工程指示 / 要求簡箋(E.I.)

工程指示編號：EI / 5538 / 22

工程名稱：將軍澳日出康城

工程項目：T1 幕牆單元件 廠用玻璃 BM 則師改倉 (344 件) 大貨 樣板層除外

DWG NO. : J858-CW-PE108 REV. : E

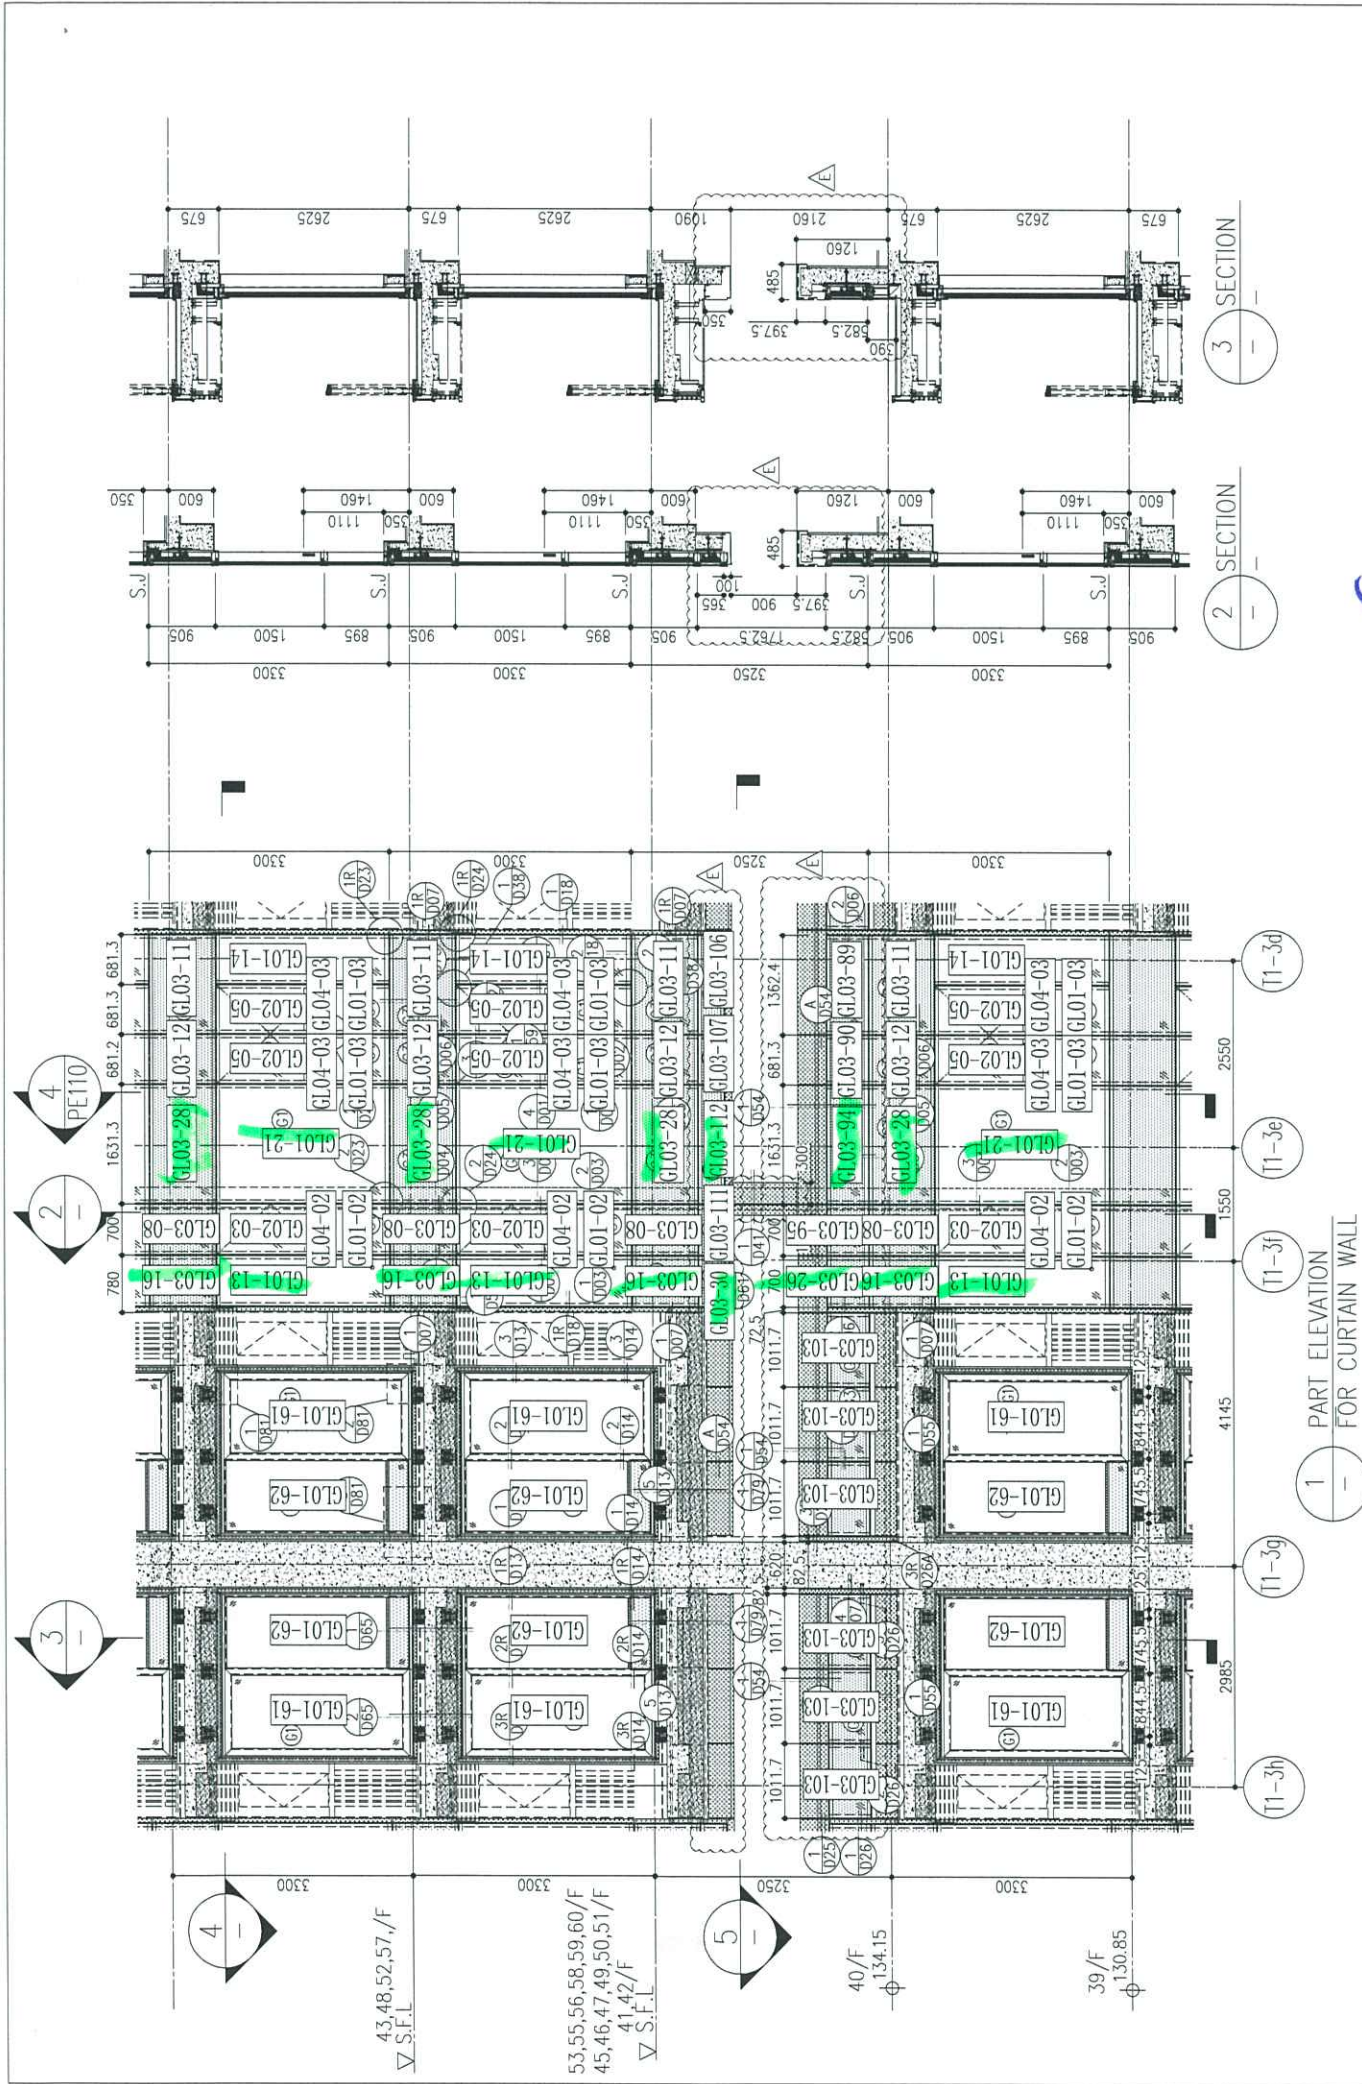
原 EI 4867B：因應則師修改尺寸 (AI-140)，減少了 376 件。

Original

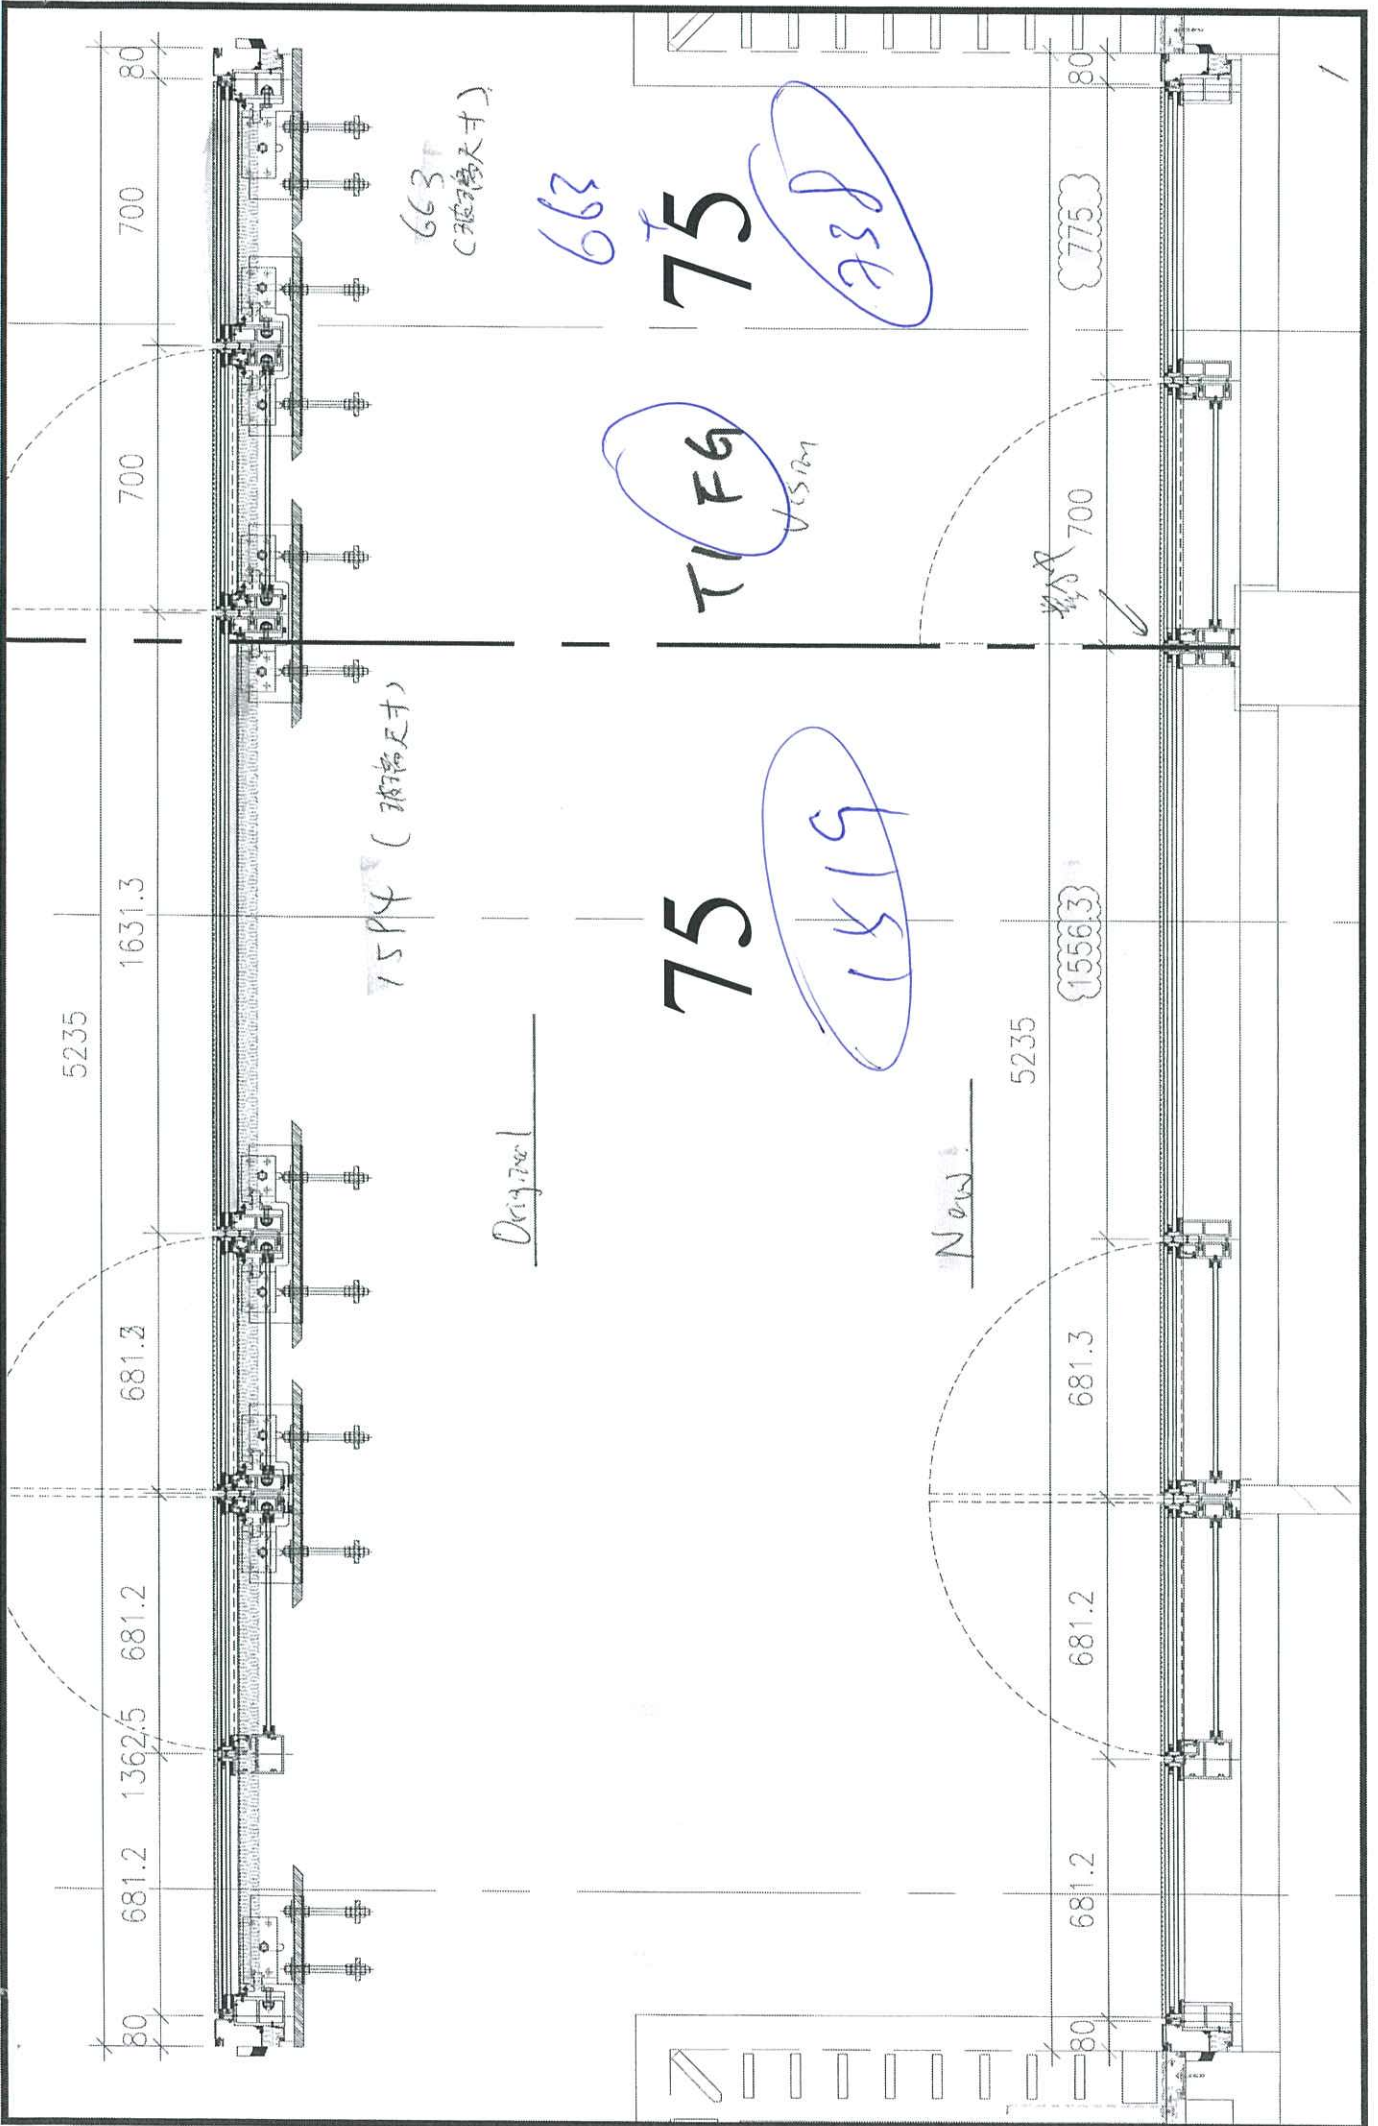
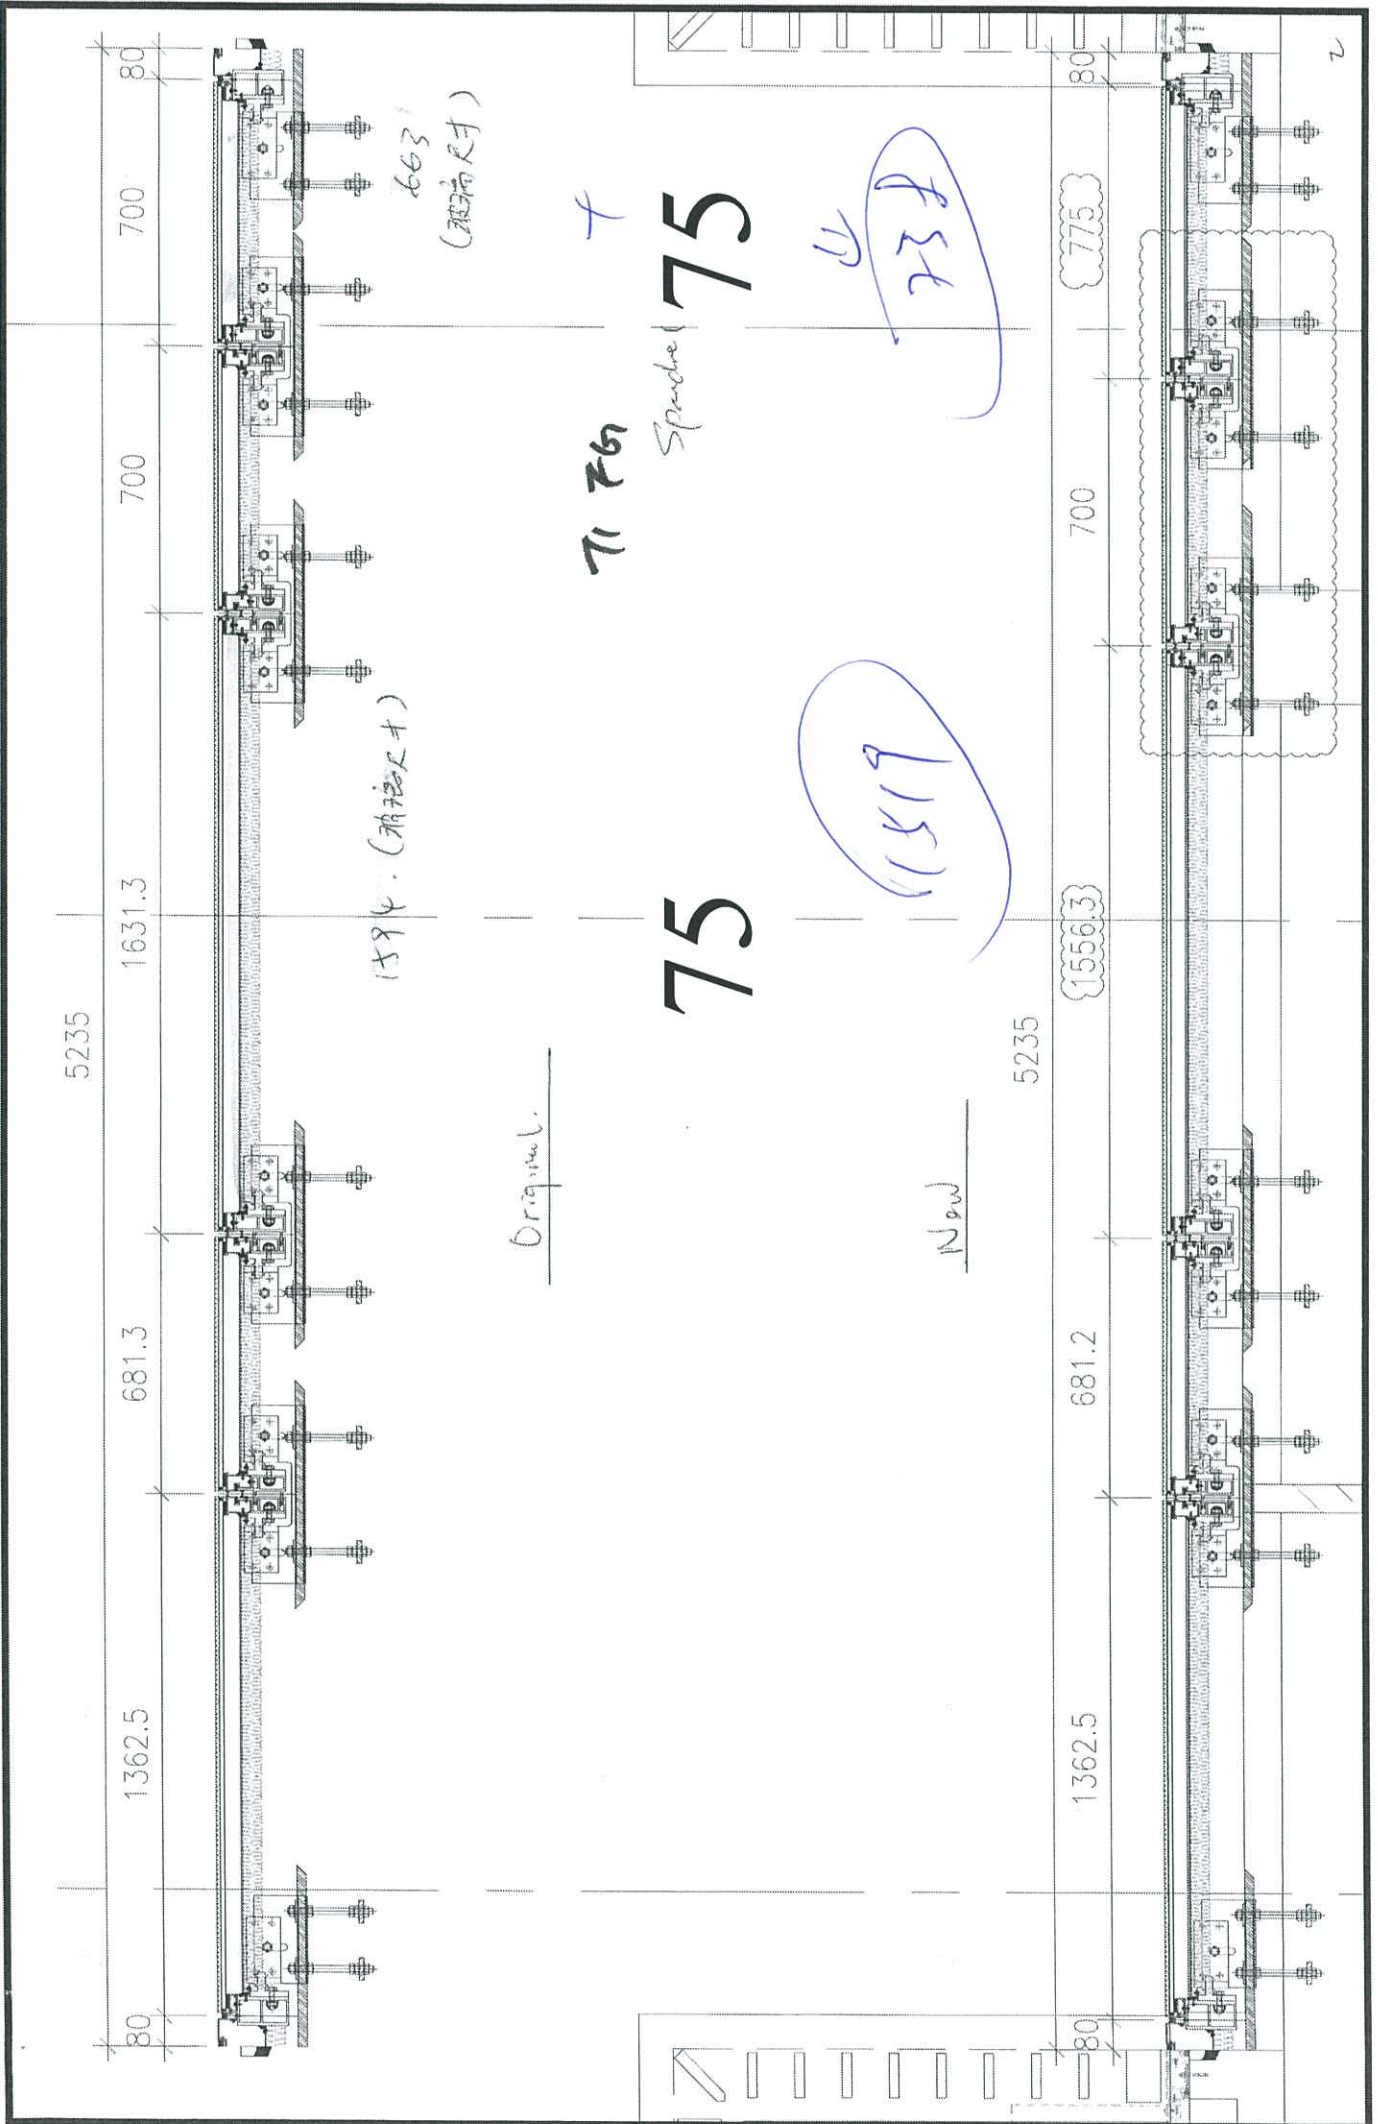
OK
修改
新加
新加
修改
修改
修改

OK
修改
新加
新加

1519

New
